1984 - 1987 Corvette: Service Bulletin: Front Center Air Deflector Damage

Subject: Front Center Air Deflector Damage

Model and Year: 1984 - 1987 Corvette

Bulletin Number: 87-263-10, Section 10

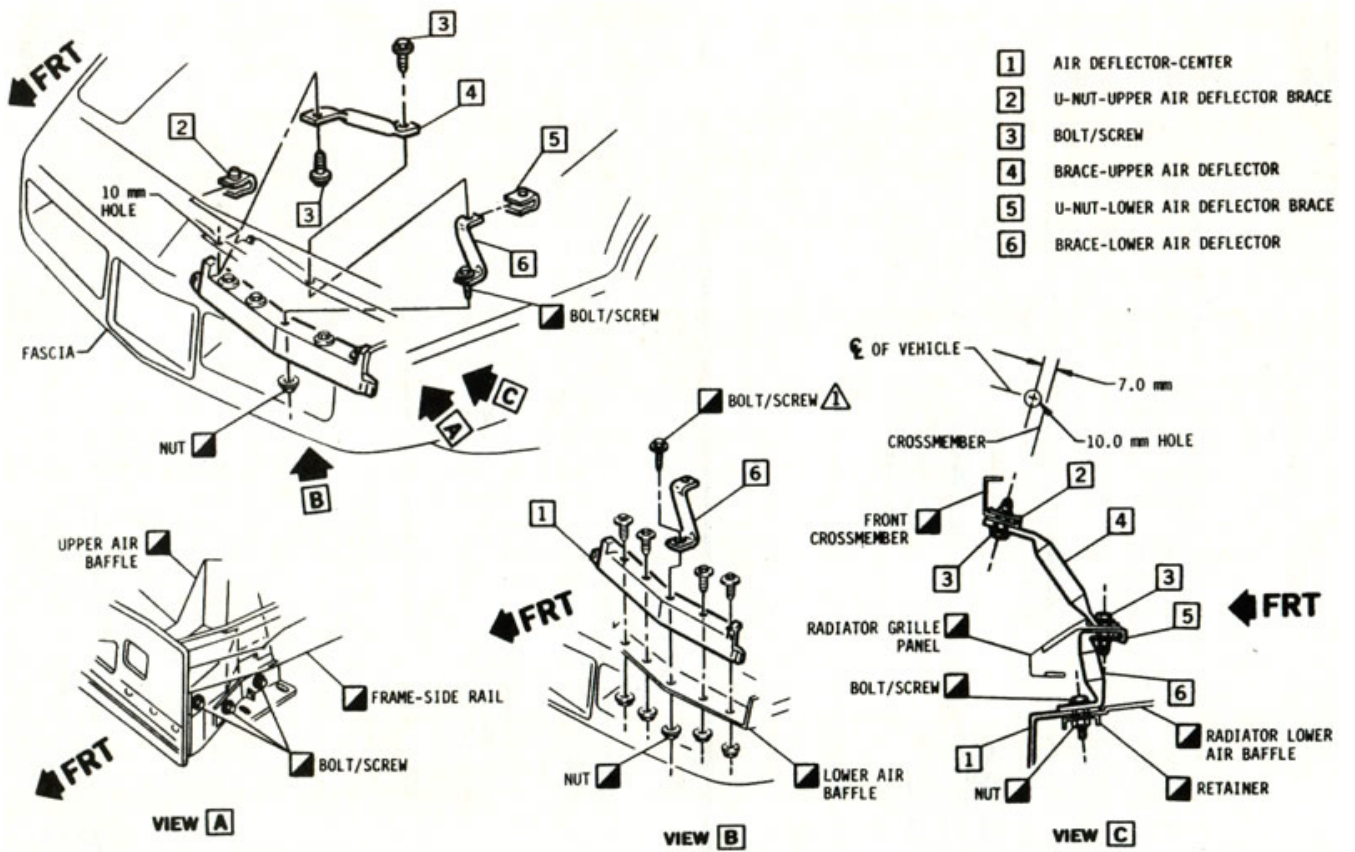
Comments that the front air deflector (dam) gets damaged by bumps, curbs and snow piles may be received. A service kit with two new braces has been released to address this situation on affected vehicles.

This condition can be addressed by installing the braces per the illustration and instructions provided in the service kit. The part numbers for the service kits are as follows:
